Item No. 8.1.2
Design Review Committee
July 7, 2016

Case 20553: Substantive Site Plan Approval, 1221 Lower Water Street,

Halifax (Discovery Centre at Emera Head Office)

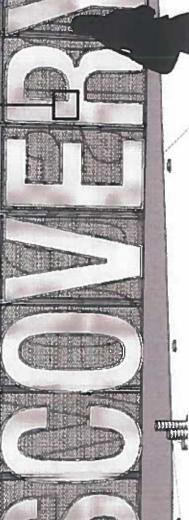
With regards to the double sided effect, it was confirmed that NSPI will not be installing a fence or gate that there was an opportunity to also have the word "DISCOVERY" on both sides of fence however we to prevent DCH visitors from entering their adjacent maintenance parking area. As such it was thought would recommend having only on the DCH walkway side for the following reasons: Reduces confusion as to which is the walkway to DCH since having it on both sides of fence might lead to visitors entering NSPI parking area

Visitors will still be guided to DCH entry by the fence itself and the Screen with Moon imagery Perforations at fence will be opaque enough so that the lettering cannot be read backwards

Cost savings by not duplicating the lettering 0 6 4

# Exterior Façade Studies: LANDSCAPING

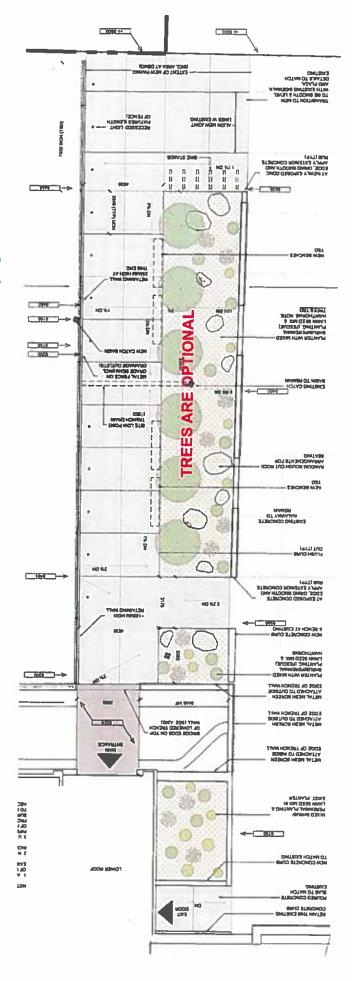
DCH: Can we incorporate local NS plant life and possibly rock/geology within the landscaping feature? ~

region. They can even come with name plates and/or small interpretive display maps for educational purposes. Refer to next slide for recommended plant species. Also note that the trees shown (ie. Washington Hawthorns) are optional as it was thought that some shade / colour would be a nice feature in the MTA/BLA: Local Nova Scotia vegetation will be used as noted below. Also the stones can be selected to highlight the various stone/geology of the foreground to the Discovery Center however DCH may find that they block direct views to the main entry & signage.
